# HISTORIC AND DESIGN REVIEW COMMISSION

**HDRC CASE NO:** 2019-524  
**ADDRESS:** 1818 SAN PEDRO AVE  
**LEGAL DESCRIPTION:** NCB 1863 BLK 3 LOT 1 & 2 W 25 FT. OF 3  
**ZONING:** C-2,H  
**CITY COUNCIL DIST.:** 1  
**DISTRICT:** Monte Vista Historic District  
**APPLICANT:** Sonia Lopez, Maximilion Ramirez  
**OWNER:** Center for Family Relations  
**TYPE OF WORK:** Door replacement  
**APPLICATION RECEIVED:** August 30, 2019  
**60-DAY REVIEW:** October 29, 2019  
**CASE MANAGER:** Stephanie Phillips  
**REQUEST:**

The applicant is requesting a Certificate of Appropriateness for approval to replace two existing Victorian-style wood doors on the front façade of the primary structure with new steel doors.

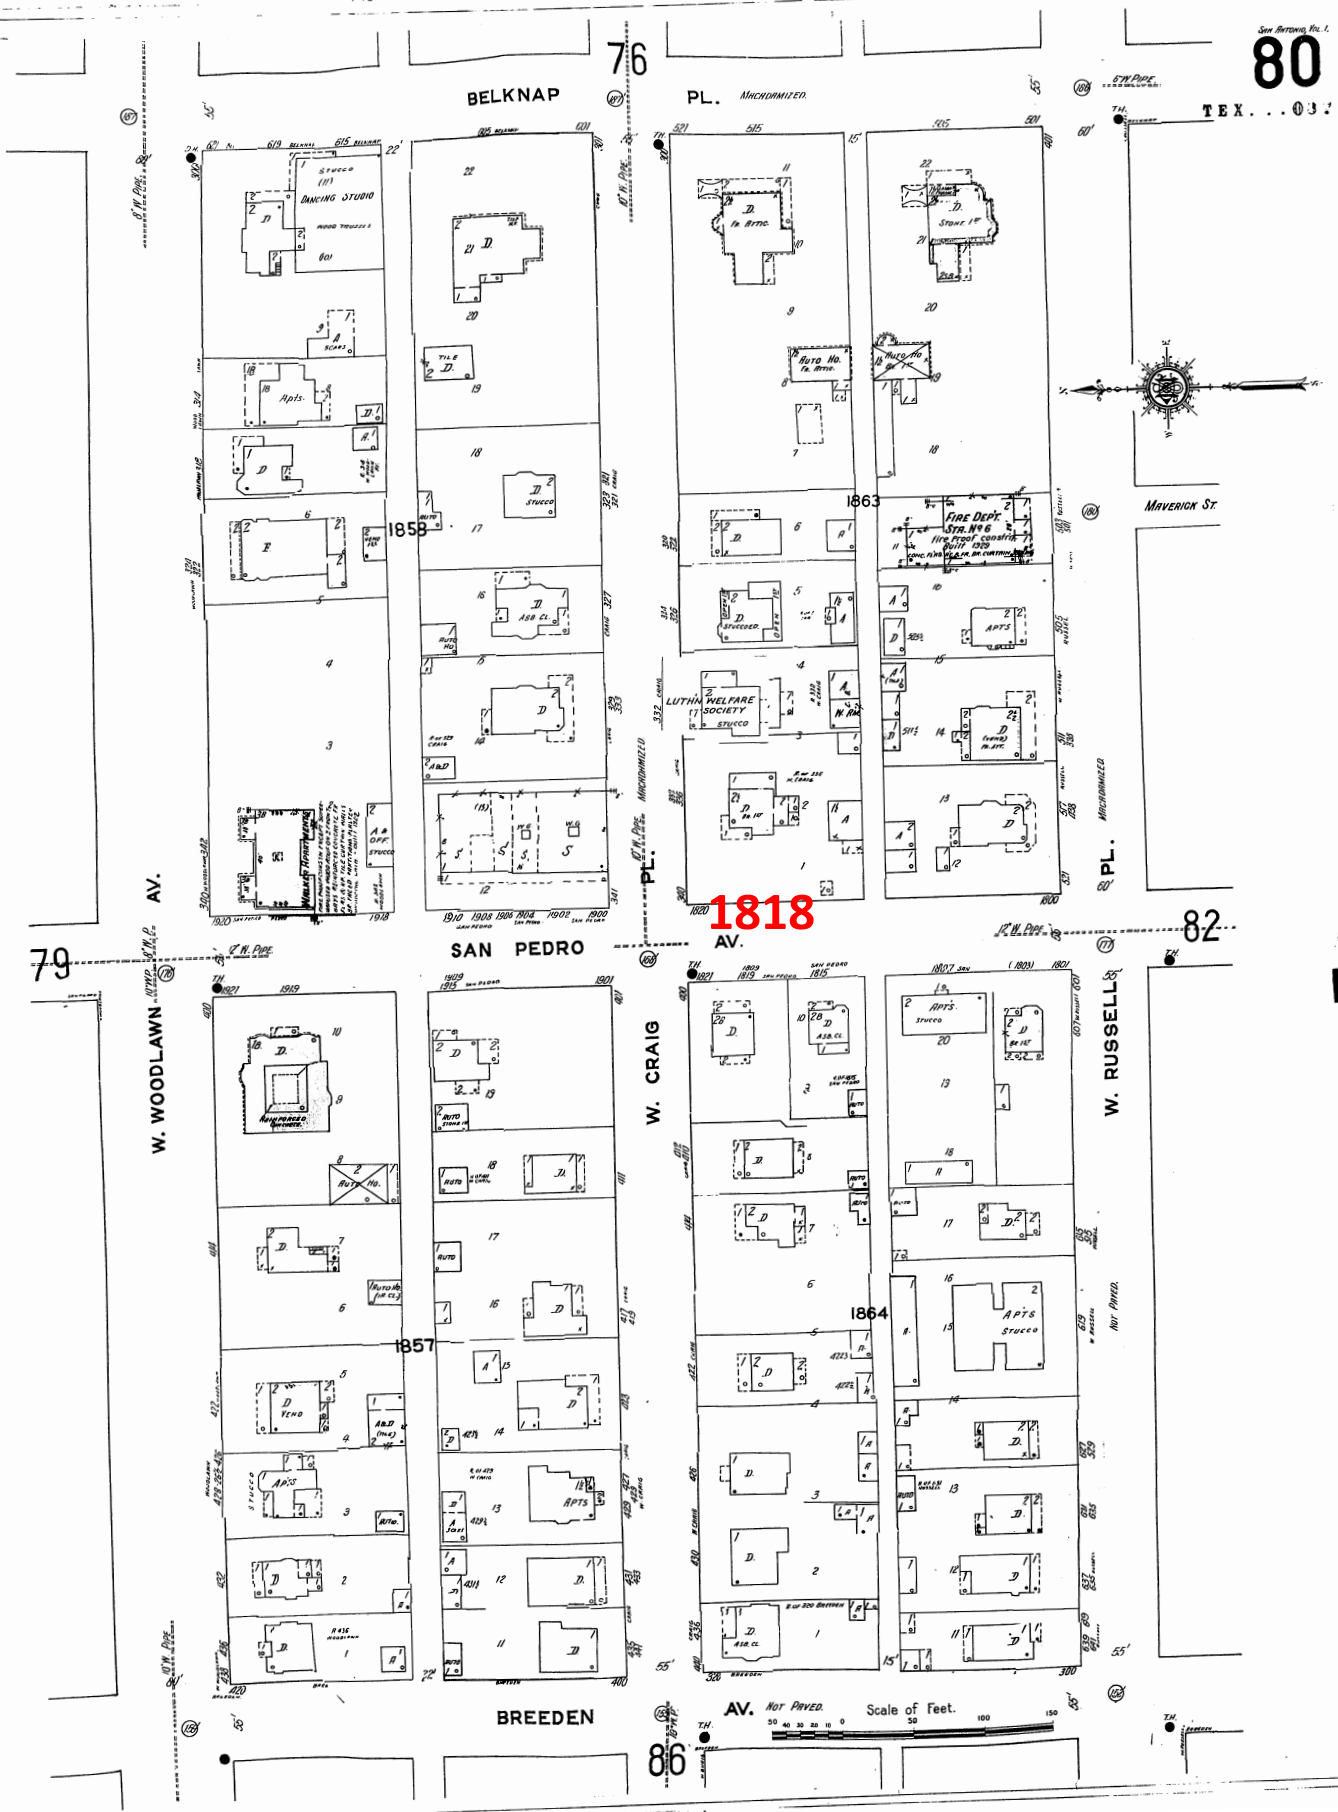
- b. **DOOR REPLACEMENT-** The applicant has requested to replace two existing front doors on the primary façade. The applicant originally submitted a Certificate of Appropriateness request for the replacement of one of the two doors. Upon review of the documentation, staff discovered that a second wooden front door had already been replaced with a new steel door. One of the doors is the primary front door off of E Craig Pl, which has already been replaced. The second door is a secondary entrance to a 1-story mass, set back from the front façade, but is visible from the public right-of-way on E Craig Pl. The doors are made of wood and feature an elaborate Victorian-era design, including carved or applied organic detailing and a shelf under the main single glass pane. According to the Guidelines, existing doors should be repaired and preserved. Staff does not find the replacement steel doors appropriate. Staff finds that the doors should be repaired.

The applicant originally submitted a Certificate of Appropriateness request for the replacement of one of the two doors. Upon review of the documentation, staff discovered that a second wooden front door had already been replaced with a new steel door.

Staff does not recommend approval based on findings a and b. Staff recommends that the doors be repaired and retained.
